HISTORIC AND DESIGN REVIEW COMMISSION

HDRC CASE NO: 2023-321
ADDRESS: 327 E KINGS HWY
LEGAL DESCRIPTION: NCB 6327 BLK 2 LOT 50
ZONING: R-5, H
CITY COUNCIL DIST.: 1
DISTRICT: Monte Vista Historic District
APPLICANT: Oscar Flores/Oscar Flores Design Studio
OWNER: Patrick Moloney/MALONEY JOHN PATRICK JR
TYPE OF WORK: New construction of a 2-story single-family structure and a 1-story rear accessory structure
APPLICATION RECEIVED: July 28, 2023
60-DAY REVIEW: September 26, 2023
CASE MANAGER: Rachel Rettaliata

REQUEST:

The applicant is requesting conceptual approval to construct one 2-story, single-family structure and one 1-story detached garage at 327 E Kings Hwy.

SHEET TITLE
 SITE ANALYSIS

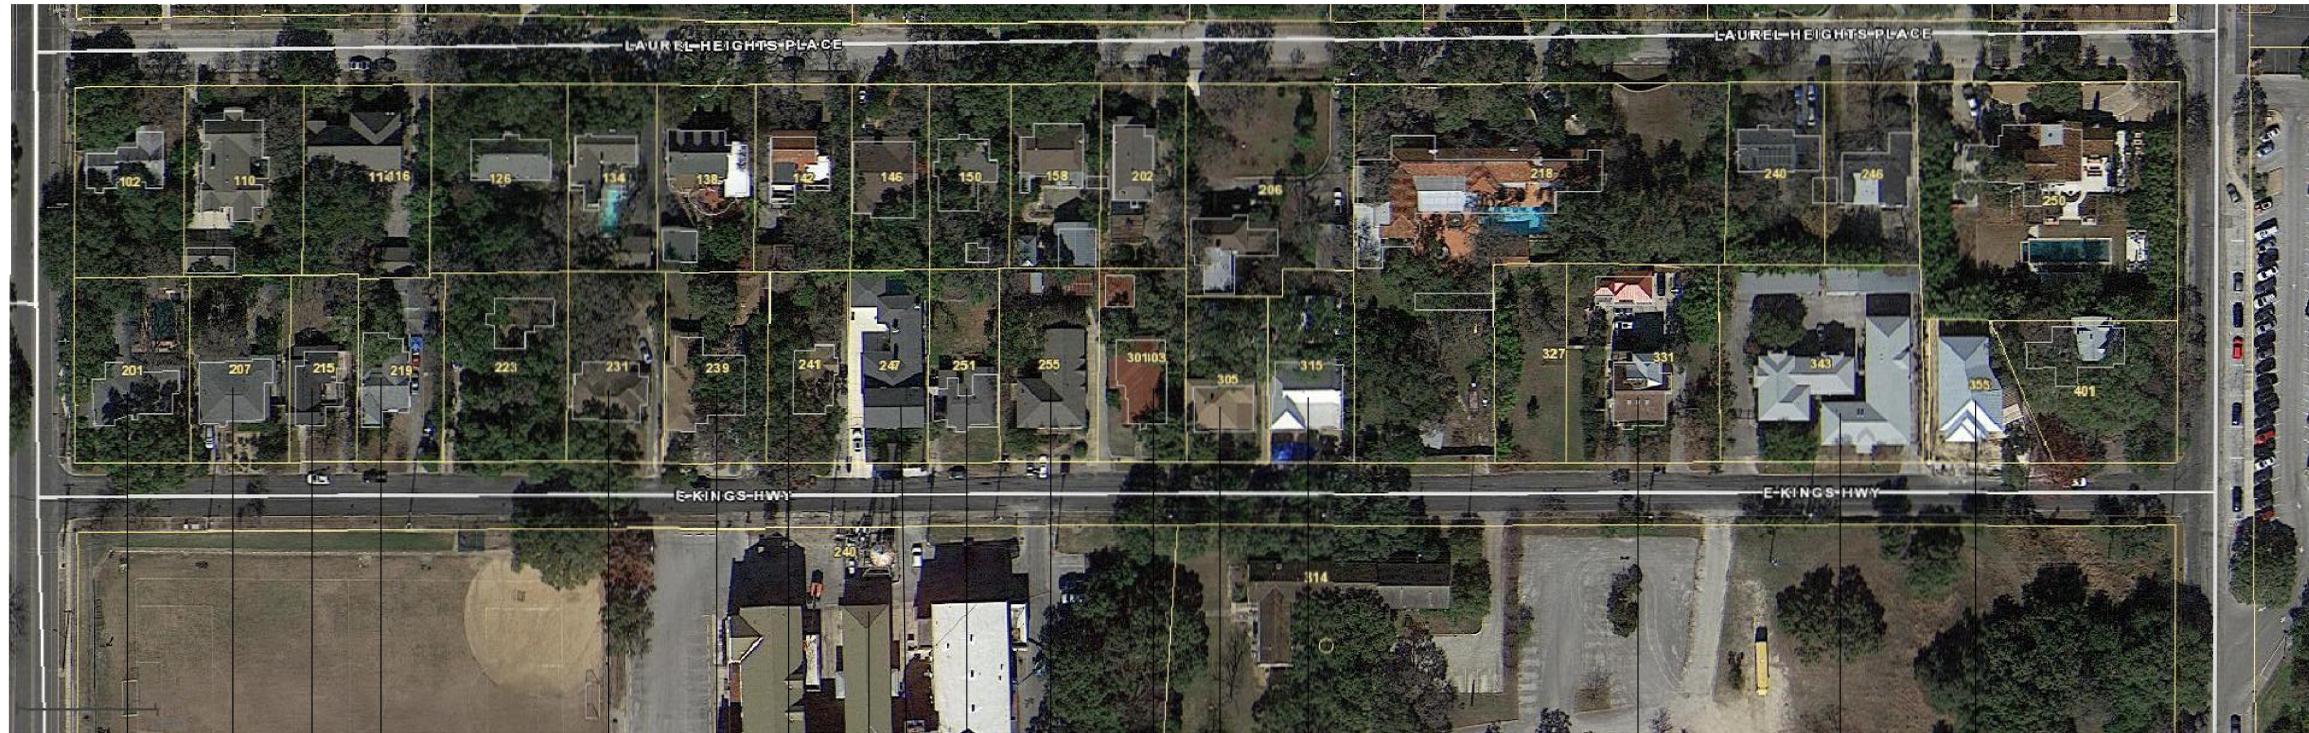
- f. SCALE & MASSING – According to Guideline 2.A.i for New Construction, new structures should feature a height and massing that is similar to historic structures in the vicinity. In residential districts, the height and scale of new construction should not exceed that of the majority of historic buildings by more than one story. This immediate block of E Kings Hwy features 1- and 2-story single family and multifamily residences. Additionally, the property is located across the street from San Antonio Academy and Lang Field. The proposed new construction will total 29'-4 ½" at the ridge height. The applicant has provided a study showing that, based on other residential structures in the district, a ridge height of up to approximately 32' is appropriate. Staff finds that the applicant should provide a height study that includes the neighboring 2-story structure for review.

- i. That the applicant provides a diagram showing the height of the proposed structure in relation to the neighboring 2-story structure, including proposed foundation and floor heights based on findings f and g.

SHEET TITLE
FRONT & REAR ELEVATIONS

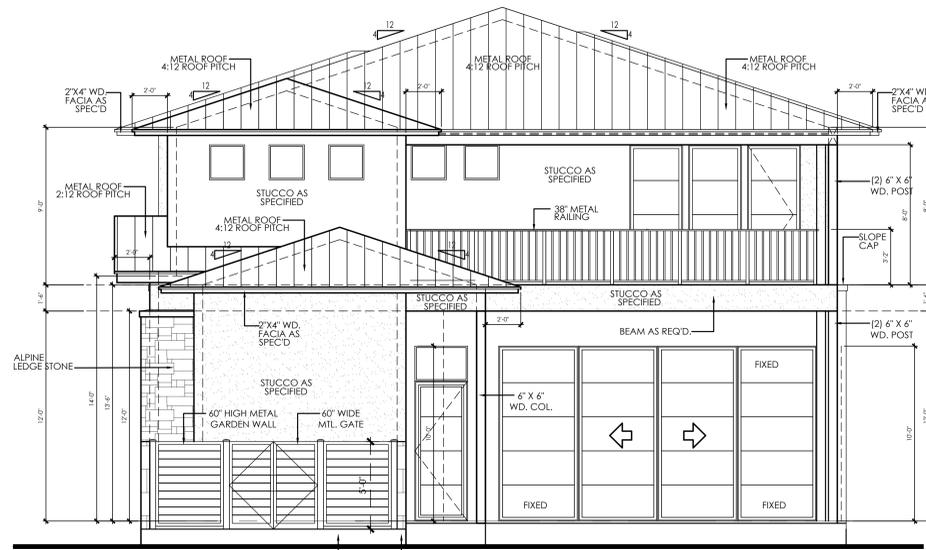
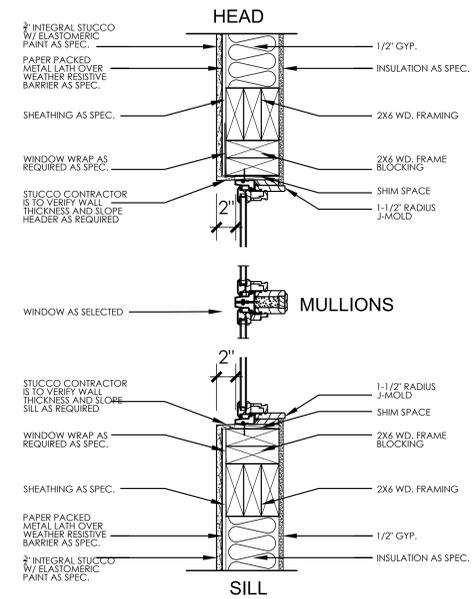
- l. RELATIONSHIP OF SOLIDS TO VOIDS – The applicant has proposed to install fixed and casement windows of various proportions and the proposed windows do not appear to be in keeping with those historically found in the district. Guideline 2.C.i for New Construction states that window and door openings should be incorporated into new construction with a similar proportion of wall to window space as typical with nearby historic facades. Windows, doors, porches, entryways, dormers, bays, and pediments shall be considered similar if they are no larger than 25% in size and vary no more than 10% in height-to-width ratio from adjacent historic facades. The proposed bay of windows on the projecting staircase volume is not a fenestration pattern typically found in the district and the proportions of the proposed fixed windows are not similar to those found on nearby historic facades. Staff finds that the proposed fenestration should be updated to be more in keeping with the Guidelines.

- iv. That the applicant proposes window sizes, patterns, proportions, and trim and sill detailing that are consistent with the Guidelines and historic precedents in the district as noted in finding l.
